Z-97
(2016)

SITE PLAN FOR
Single-Family Homes (RA-5)
#1189 Vester Drive
Landlot 962 of the 16th District
Marietta, Cobb County, Georgia

Z-97-2016 GIS

ZONING COMMENTS:

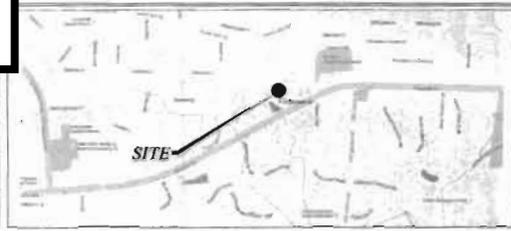
As the proposed development abuts a cemetery to the west, a cemetery buffer may be required along this side that is not shown on the current site plan. Also, a ten foot landscape buffer will be required along the northern edge where the development abuts a more restrictively zoned property.

Cemetery Preservation: Zoning petition Z-97 2016 (in land lot 962 of the 16th District) shows the presence of Antioch cemetery on the western border of the project. The Cobb Cemetery Preservation Ordinance and the County Development Standards for Cemeteries call for:

- No Stormwater controls shown _____
- Copy of survey is not current – Additional comments may be forthcoming when current site conditions are exposed.
- No site improvements showing on exhibit.

1. This site is located at the northwest intersection of Roswell Road and Vester Drive. Approximately one quarter of the site is currently occupied by a 0.5 acre lake that is located in the center of the parcel. The storage effect of this lake provides a stormwater mitigating benefit for downstream property owners that must be maintained or recreated within this redevelopment.
2. The proposed layout will also need to accommodate an adequate drainage system to convey the existing upstream runoff through the site. This will require a 20-foot drainage easement along the rear of Lot 4 and between Lots 3 & 4.

1. Maximum of three (3) units per acre;
2. Site plan to be approved by the District Commissioner;
3. Code-required ten foot landscape buffer adjacent to northern neighbors to be reviewed and approved by County Arborist;
4. Cemetery Preservation Commission comments and recommendations;
5. Water and Sewer Division comments and recommendations;
6. Stormwater Management Division comments and recommendations; and
7. Department of Transportation comments and recommendations.
